Star Charge Firmware Release Note - E407

NovaV4 Power Cabinet(Standard)

Version Change Record For Power Cabinet Nova 720 - Feb 02, 2026

E407 OTA Path

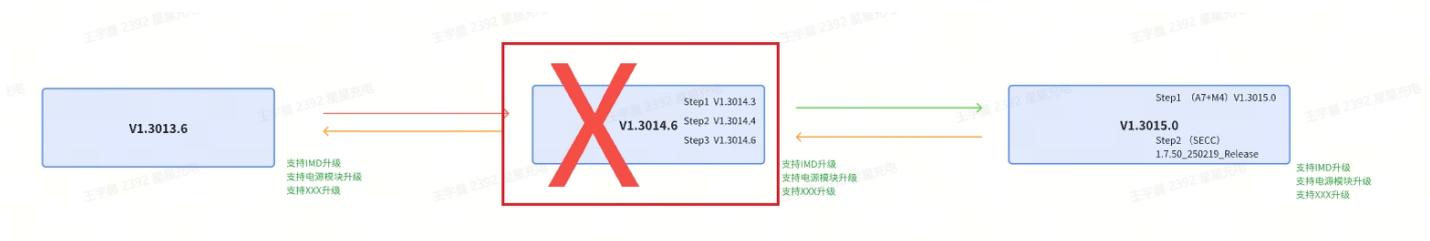
The orange arrow indicates that it only supports SD card upgrades and does not support OTA upgrades.

The red arrow indicates that the version must be upgraded, which can be done via OTA upgrade.

Green arrow, representing a version whose upgrade can be skipped, can be upgraded via OTA.
